# Access Compliance Report

## Public Rights-of-Way

### (Curb Ramps)

Intersection ID: 2419	Main Street: LAUREL_RUN_DR	Cross Street: WILDBROOK_DR	Location: N
ADA ID: 380F210308D5	Ramp Type: PerpDiag	Initial Pass/Fail: Fail	Overall Compliance: No
			Severity Score: 33.75

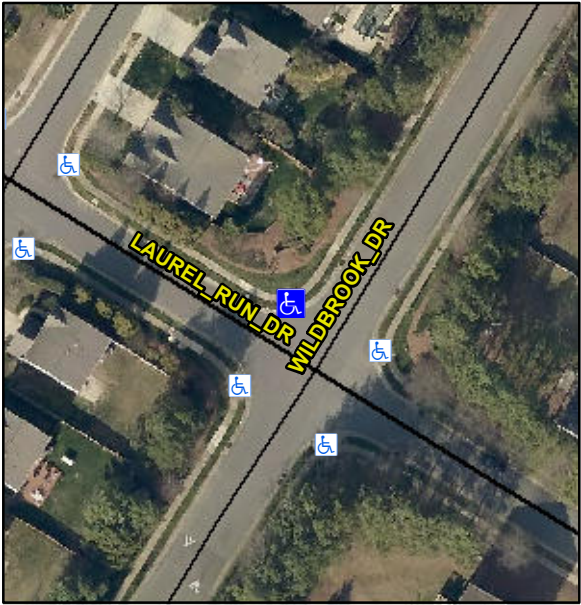
Codes/Mitigation Info/Possible Solution			Field Measurements/Component Compliance			
	Possible Solutions:		<b>Compliance</b>	<b>Description</b>	<b>Data</b>	
	<b>Remove &amp; Replace Curb Ramp With Two New Directional Ramps or Equivalent.</b>		N/A	Ramp Length (in)	100.0	<b>Yes</b>
			No	Ramp Width (in)	39.0	<b>No</b>
			N/A	Flare Type LT	N/A	N/A
			N/A	Flare Slope LT (%)	N/A	N/A
			N/A	Flare Traversable LT?	N/A	N/A
			N/A	Landing Length (in)	N/A	N/A
			N/A	Landing Width (in)	N/A	N/A
			N/A	Landing Slope (%)	N/A	N/A
			N/A	Landing X Slope (%)	N/A	N/A
<p>Surveyor Notes:</p> <p><b>N/A</b></p> <p>PROW/ADA:</p> <p><b>R304.5.1, R304.5.3</b></p>			N/A	Flare Type RT	N/A	N/A
			N/A	Flare Slope RT (%)	N/A	N/A
			N/A	Flare Traversable RT?	N/A	N/A
			N/A	DWS Provided?	N/A	N/A
			N/A	DWS Contrast?	N/A	N/A
			N/A	DWS Length (in)	N/A	N/A
			N/A	DWS Full Width?	N/A	N/A
			N/A	DWS Offset (in)	N/A	N/A
			N/A	Gutter Ponding?	N/A	N/A

N/A	Gutter Lip Ht (in)	N/A	N/A
			N/A	Painted X Walk1?	No	N/A
				X Walk 1 Direction	To SW	
			N/A	X Walk 1 Width (in)	N/A	N/A
				X Walk 1 Slope (%)	4.3	
				X Walk 1 X Slope (%)	8.3	
			N/A	Ramp inside XWalk1?	N/A	N/A
				Road Slope (%)	6.5	N/A
				Road X Slope (%)	0.8	N/A
			N/A	Any Obstructions?	N/A	N/A
				Obstruction Type		
Total Cost:			\$	3200.00		
			N/A			N/A
			Yes	Surface Condition? (G/P)		Good
